DRAFT WATER QUALITY IMPACT EVALUATION

Florida Department of Transportation

S.R. 70 PD&E Study

Limits of Project: From C.R. 721 S to C.R. 599/128th Avenue

Figure 3 A snip of a recommended Pond 6C location.

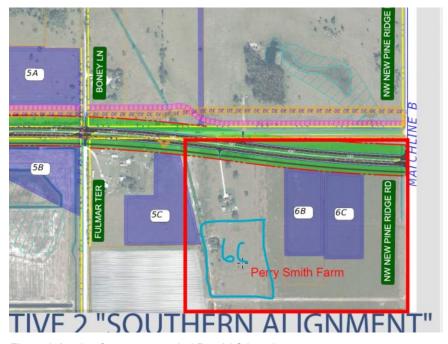
- iii. Dale Smith suggested using a compensating pond near Fulmar Terrace and Pond 5C for a pond alternative. He also suggested an existing permitted reservoir located at the southern end of his property could potentially be retrofit for a FDOT stormwater pond, which he offered to coordinate. Brent commented that the current pond 6C location is not preferred and that using the reservoir would require multi-agency coordination. The FDOT will consider various alternatives to avoid impacts on the irrigated fields near 6B and 6C pond locations.

- iv. FDOT and Scaler will update the pond 6C alternative to be south of the house and east of the canal as depicted in the graphic below to avoid the irrigated fields and be closer to the pond outfall.
